Fw: UEC Tx amendment
Ray Leissner to: charles.maguire
Cc: Stacey Dwyer, Philip Dellinger

Re: Amended Request for Approval of Non-Substantial Underground Injection Control (UIC) Program Revision to Establish an Aquifer Exemption in the Goliad Formation, Goliad County

Sent from my iPhone 11-16-12 Letter to EPA-Honker Goliad AE.pdf ATT00001.htm revised ae map with seal.pdf

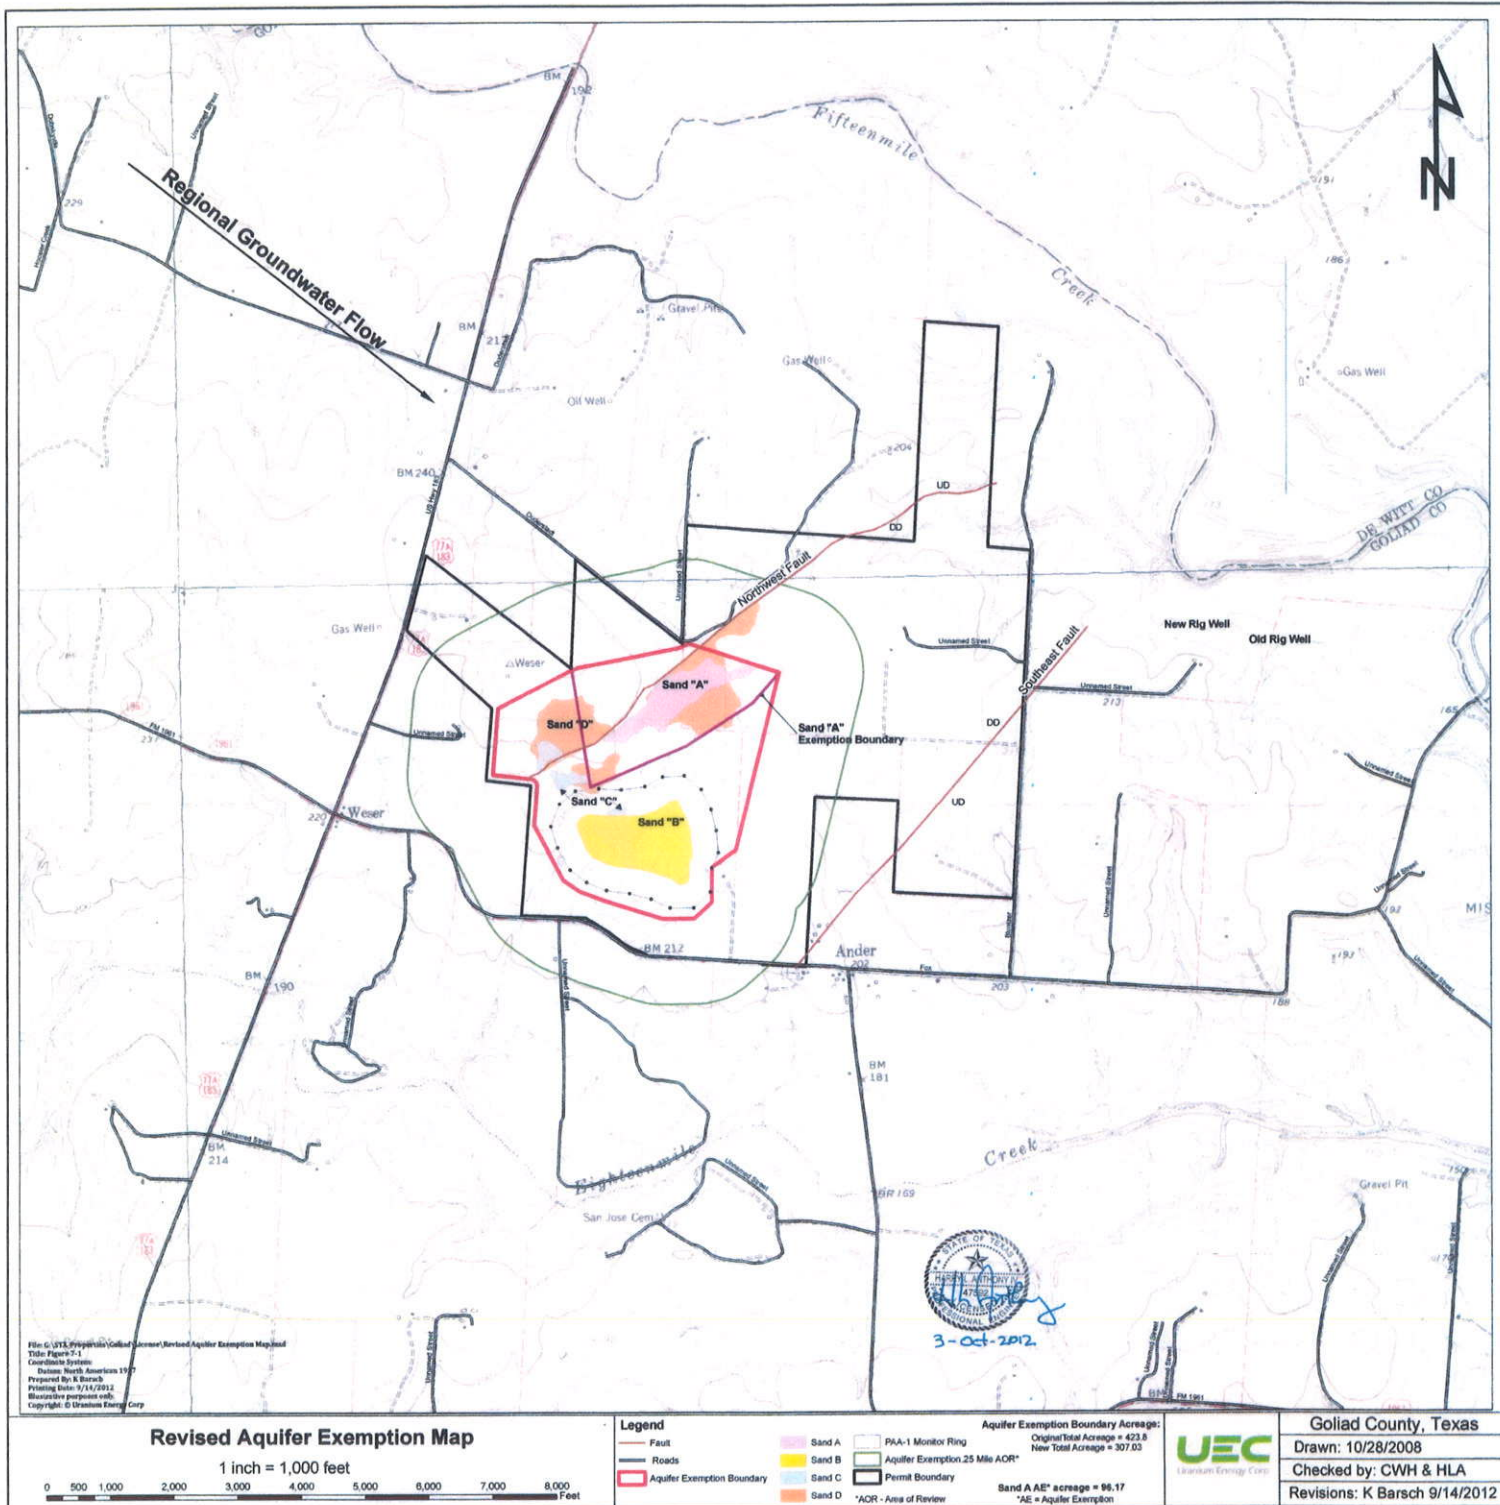
Notwithstanding the TCEQ's opinion that the submitted program revision request meets all applicable regulatory requirements, in a letter dated October 3, 2012 (received October 4, 2012), UEC has requested that the TCEQ's program revision to EPA be revised to reflect the following changes to this aquifer exemption:

The exempt area for Sand A be reduced from 423.8 acres to 96.17 acres; and

The exempt area for Sand B, Sand C, and Sand D be reduced from 423.8 acres to 307.03 acres.

In the exempt area for Sand A, the exemption will extend for a depth of 45 feet to 110 feet. In the exempt area for Sands B, C, and D, the exemption will extend from a depth of 110 feet to 404 feet. A copy of UEC's correspondence and a map of the revised area are enclosed. UEC explains that approximately 117 acres have been removed from the original exempted area for Sands B, C, and D, and 327.63 acres have been removed from the original area for Sand A and that private water wells within the buffer zone surrounding the revised area are not capturing groundwater from the designated exempted aquifer. The revised and reduced portion of the aquifer is completely within the exempted aquifer approved by the TCEQ on April 29, 2012; no additional portions of the aquifer are proposed to be exempted. Although the TCEQ does not consider this
